Correspondence Between Staff and Applicant
Approval Letter

Re: 1155-PA-2014
7-ZN-2015#2
Marquee

MARQUEE PROJECT
(7-ZN-2015#2 AND 8-DA-2018)
Response to 2nd Review Comments

Site Plan

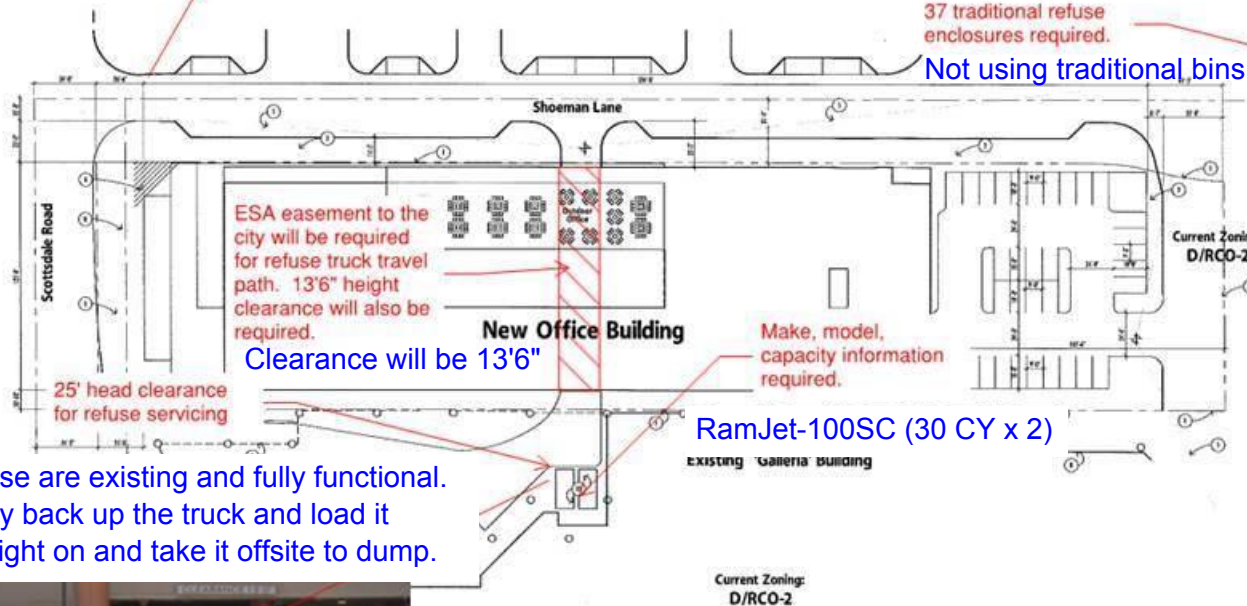
10. Please provide specific setback dimensions on Scottsdale Road and Shoeman Lane, for the building face (outside of columns) and the building face interior to the arcade, from back of curb, both inside the parallel parking spaces and at the outside curb.

This has not been addressed: Provide the street cross section, sidewalk width, pavement striping, and parking configuration for Shoeman Lane from Scottsdale Road to Buckboard Trail, both sides of the street. See landscape / Site plans. Let us know if you need a civil plan as well.

PLEASE REFER TO CURRENT DESIGN EXHIBITS SUBMITTED WITH THIS RESPONSE LETTER. SETBACK DIMENSIONS ARE ILLUSTRATED THROUGH CROSS SECTIONS PROVIDED AT BOTH SCOTTSDALE ROAD AND SHOEMAN LANE.

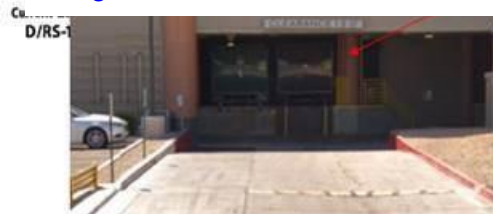
7. Please provide a formal response and revisions as necessary in response to the March 6, 2019 email regarding preliminary trash service design, attached to this letter for reference.

These are existing and fully functional. They back up the truck and load it straight on and take it offsite to dump.
